# **Fishermans Bend Planning Review Panel**

## **Draft Amendment GC81 in the Fishermans Bend Urban Renewal Area**

STATEMENT TO THE PLANNING PANEL APPOINTED BY THE MINISTER FOR PLANNING FOR  
AMENDMENT GC81 IN THE FISHERMANS BEND URBAN RENEWAL AREA BY CHARMAINE DUNSTAN,  
TRAFFIC ENGINEER

Figure 11: Map 3 Open space layout (Source: Exhibited Clause 37.04 – Schedule 4 of Melbourne Planning Scheme)

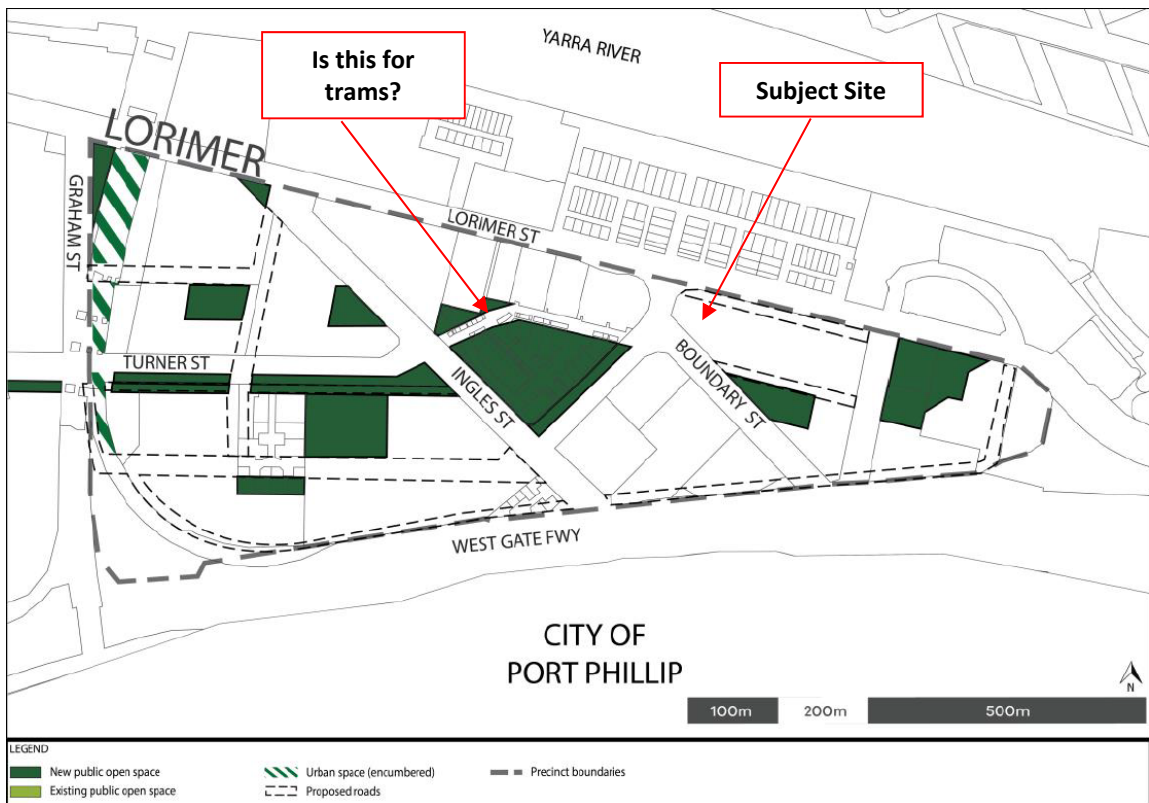
Figure 11 illustrates the open space layout in Lorimer. This plan is consistent with the other plans in proposed Schedule from a transport perspective. However, this plan clearly highlights that a 'transport link' (or at least 'open' white space) of some form is intended to run on the north side of the park proposed on the corner of Rogers Street and Ingles Street.

**Figure 12: Proposed Road Network around Subject Site (Active frontages not shown)**

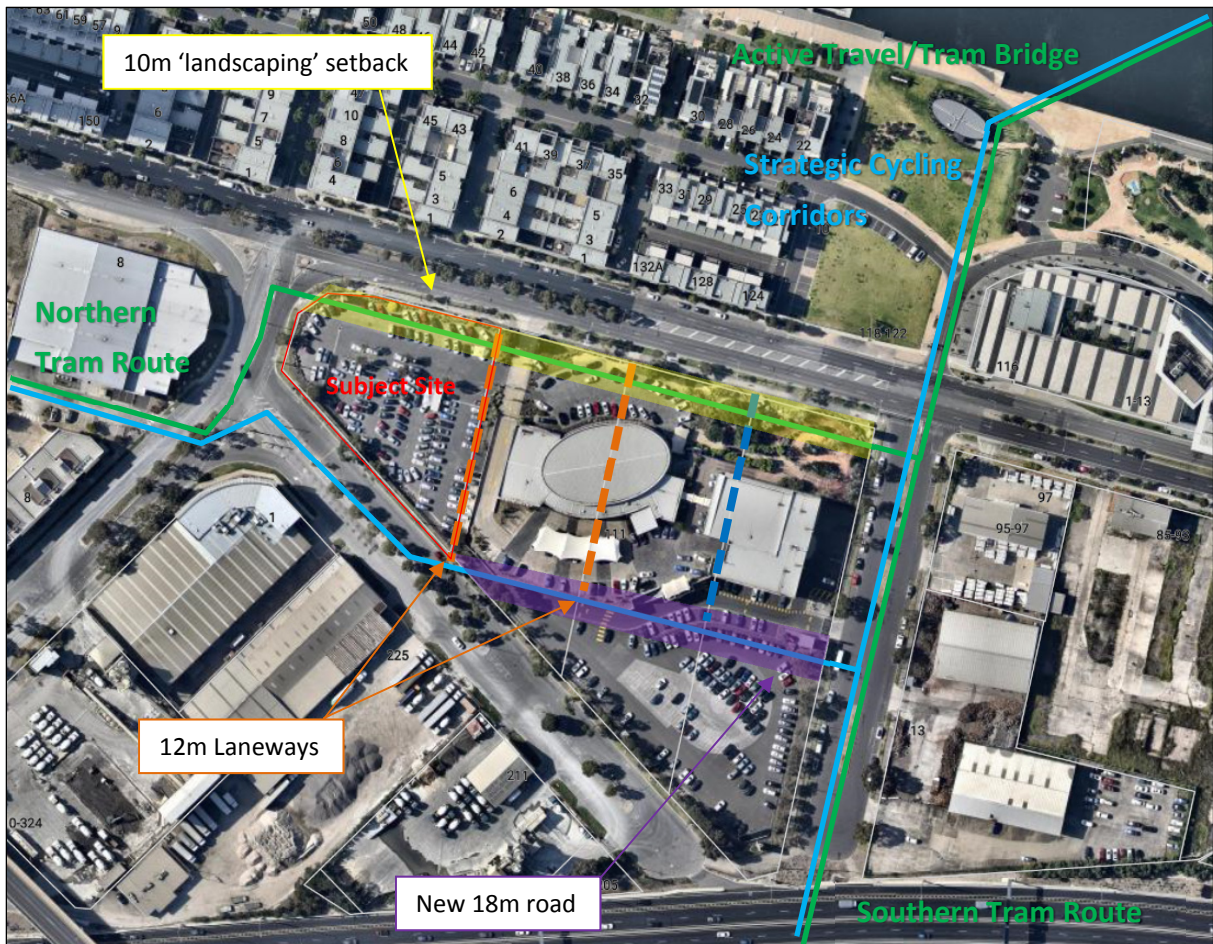
The following diagram summarises the transport challenges of the site as I have interpreted them from the controls. It does not highlight that the site's frontages to Lorimer Street, Rogers Street and Boundary Street are also primary or secondary active frontages (and undesirable for vehicle access).

- There remains uncertainty about how the northern tram route will be delivered between the Yarra and Turner Street and its consequential impact on the subject site.
- Is the setback to Lorimer Street a true 'landscaping setback' or a 'road' intended to accommodate a separate tram right-of-way?
- From reviewing the planning controls only, it is not clear where vehicle access to the subject site should be located.
- The proposed 12m wide laneway on the site's eastern boundary which appears to be intended to provide vehicle access is not shown in the planning controls and is only identifiable upon a detailed review of the Framework.

Figure 14: Current Town Planning Application Plans

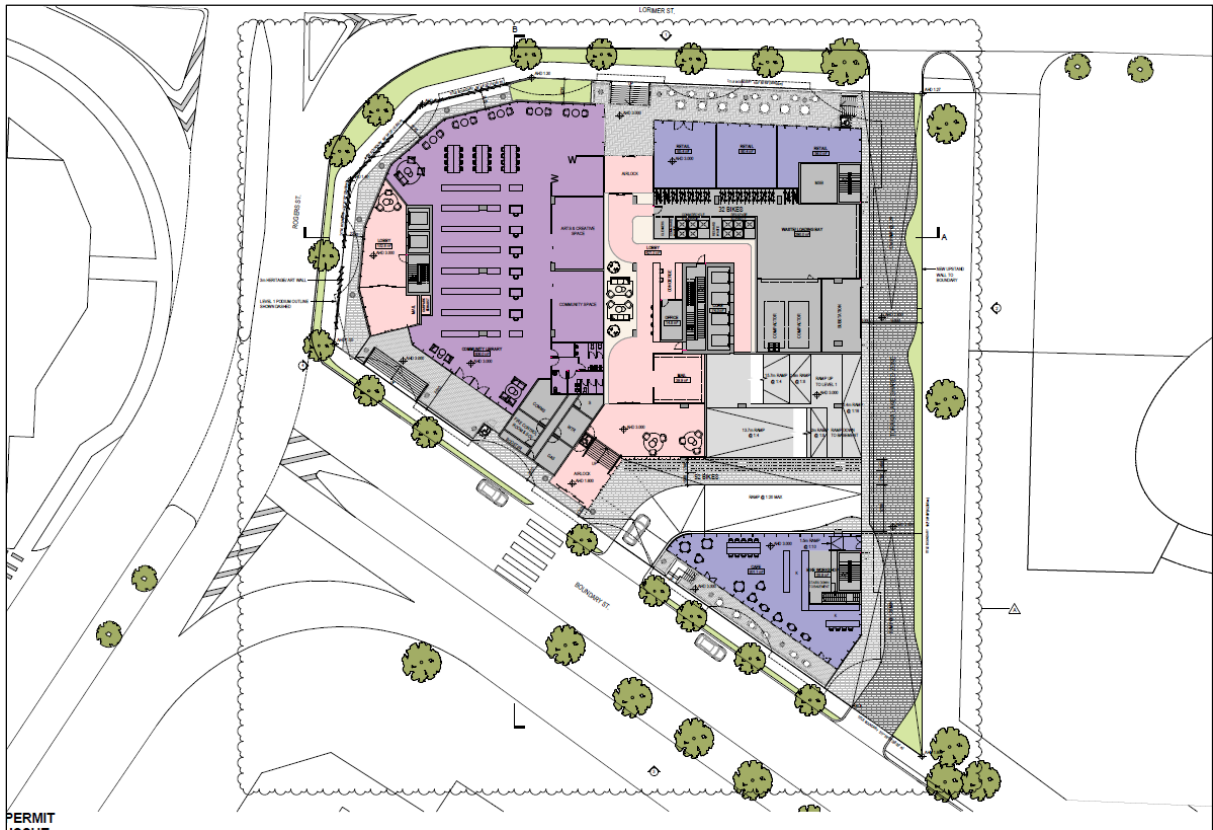
The figure below illustrates the current ground floor plan for the planning permit application for 99-111 Lorimer Street. Based on my review of the proposed controls and supporting documents, it does not appear that the current plans would be acceptable. However, I am also not sure what would be the preferred vehicle access outcome for this site. Clearly, there needs to be some flexibility when applying the planning controls regarding vehicle access to this site as the most likely suitable outcome will be an access for the sole use of the site to Boundary Street.
